A Review of the Oconee-3 Probabilistic Risk Assessment

Internal Events, Core Damage Frequency

Prepared by N. A. Harlan, D. Ilberg, D. Xue,
R. G. Fitzpatrick, T-L. Chu

Brookhaven National Laboratory

Figure 3.1 OPRA event tree for transient initiating events.

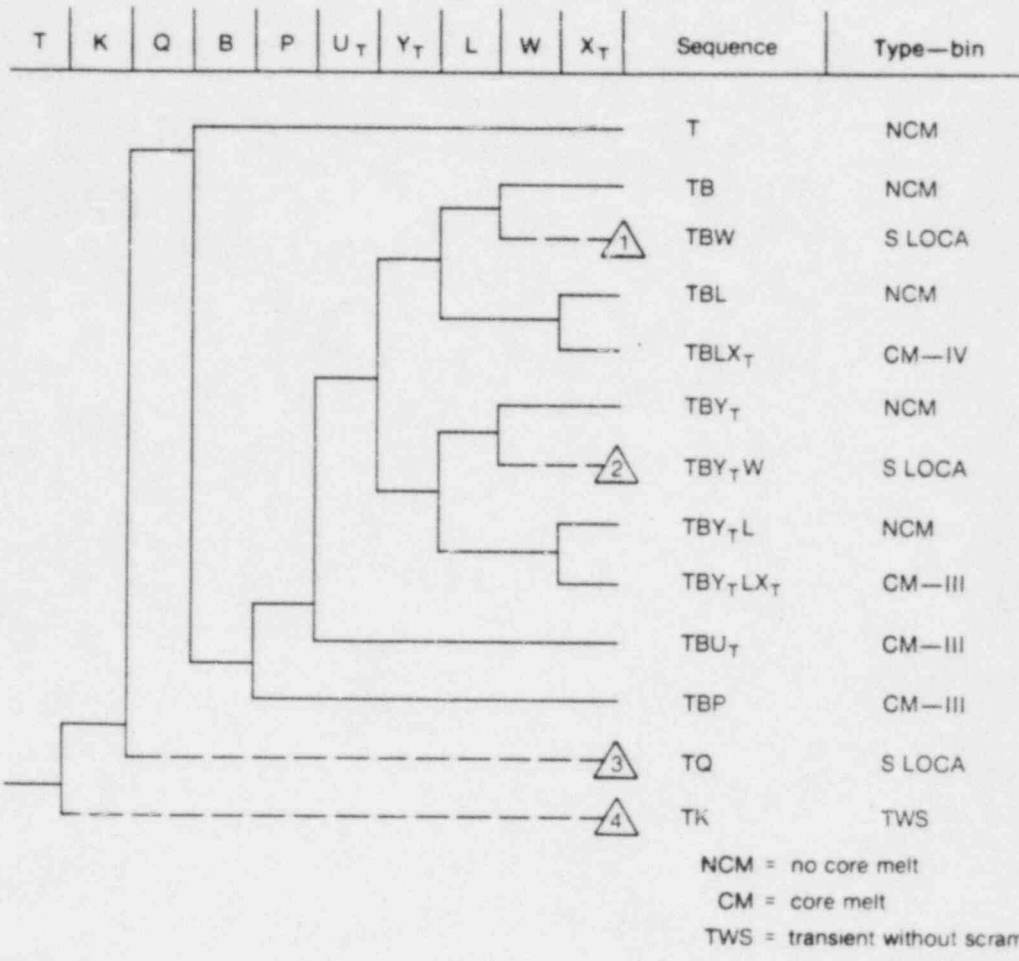
In conclusion, BNL's review of the OPRA functional event tree for transients found that it correctly represents a detailed qualitative model of the plant response.

Figure 3.17 OPRA scoping event tree for turbine trip with failure to scram.

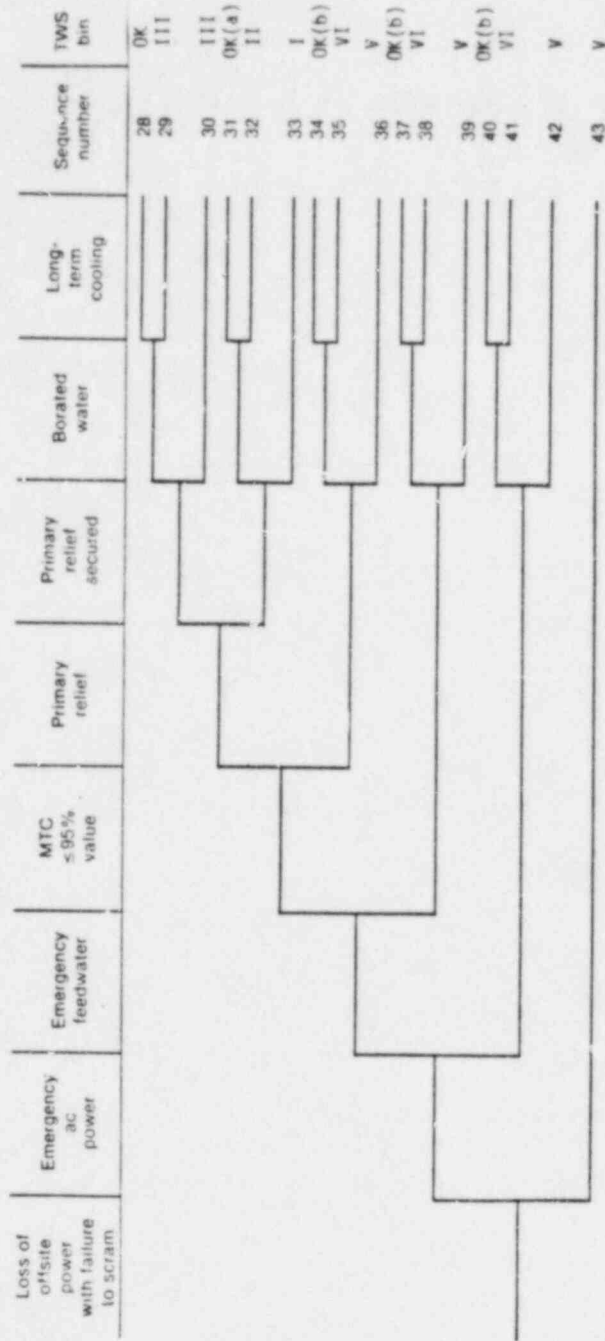
On the basis of the above information, this review is in qualitative agreement with the ATWS event trees constructed in the OPRA (Figures 3.17 through 3.20), and only the analysis of the turbine trip ATWS (Figure 3.17) will be discussed here.

The first two top events in Figure 3.17 evaluate the question of successful main feedwater, M, or emergency feedwater, L. For the case where both of these systems are not successful the OPRA assumes that a LOCA would occur and the injection of borated water from the BWST, function I, is still possible, and if this function is successful the question of long-term cooling, function X, is asked.

Figure B.1 Scoping event tree for turbine trip with failure to scram.

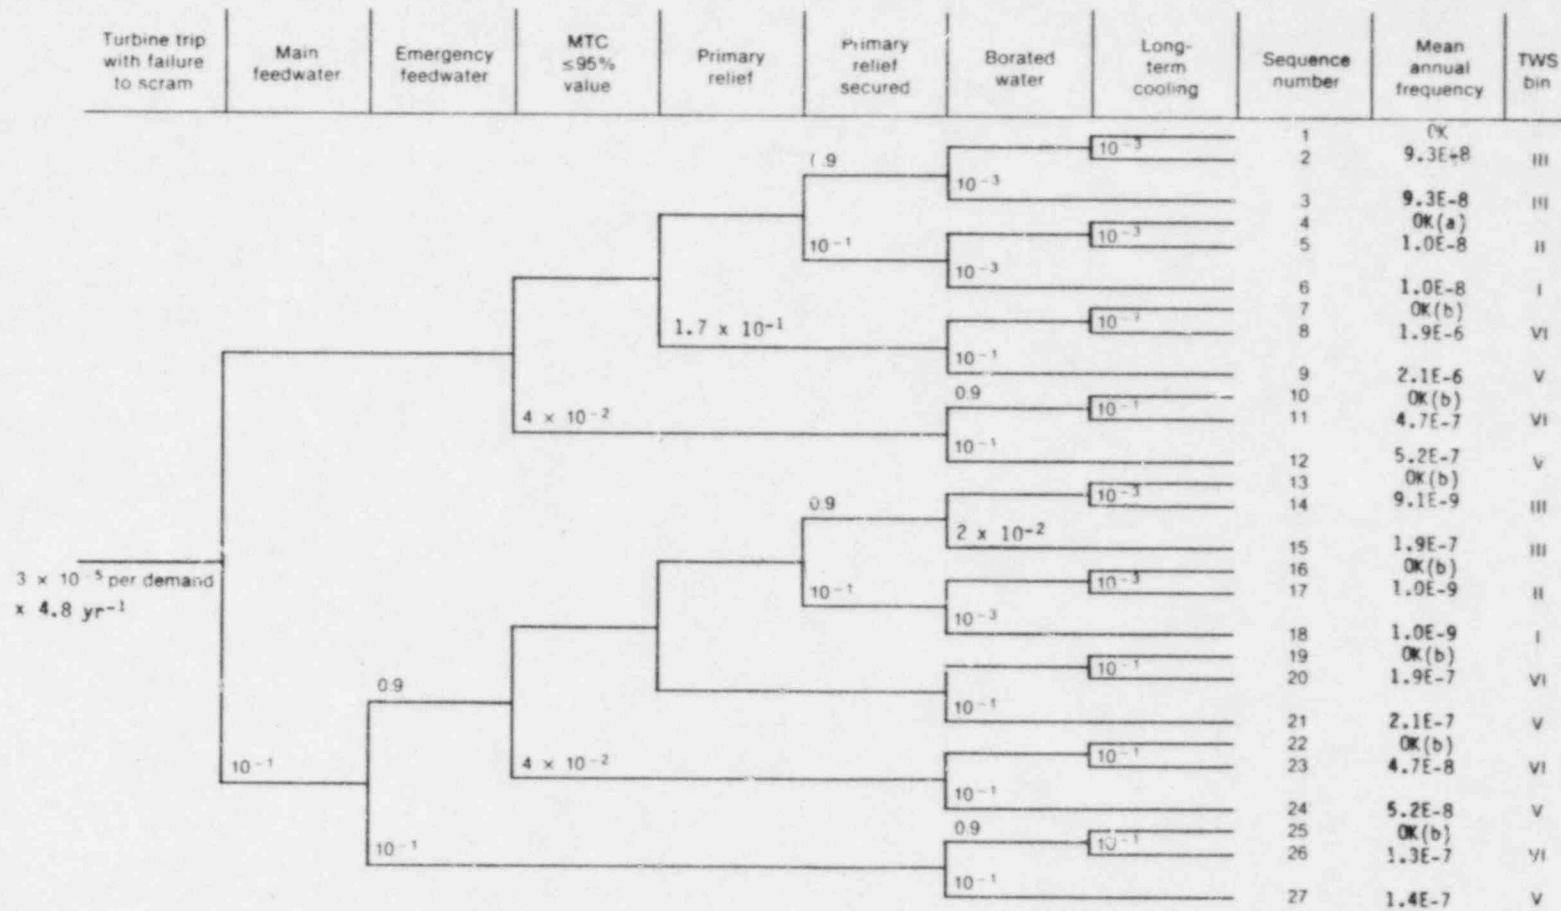
3. The OPRA makes a mistake when evaluating sequences 14 and 15 of Figure E-1 in Appendix E of the OPRA. A value of 0.1 is used for the top events "Borated Water" and "Long-term Cooling" (instead of $1.0E-3$ as used in all equivalent sequences in the other event trees, and as discussed in the OPRA Appendix E). Correction of this error would bring down the total ATWS core damage in the OPRA from $6.0E-6$ /yr to about $3.6E-6$ /yr. In this review, a different probability is used for this event, as will be discussed below.

To summarize, the ATWS core damage frequency given in the OPRA is equal to $6.0E-6$ /yr; however, if this frequency is corrected to take into account an error in the probabilities given in sequences 14 and 15 event tree for ATWS turbine trip (OPRA, Appendix E, Figure E-1), the correct OPRA core damage frequency would be equal to about $3.6E-6$ /yr. This CD frequency is to be compared with the value of $7.7E-6$ /yr calculated in the base case of this review. Note that if the PORV block valve is open during all times the plant is in operation, as stated in a Nov 26, 1985 letter from H. B. Tucker (DPC) to H. R. Denton (NRC), the ATWS core damage frequency calculated in this review is equal to about $3.4E-6$ /yr.
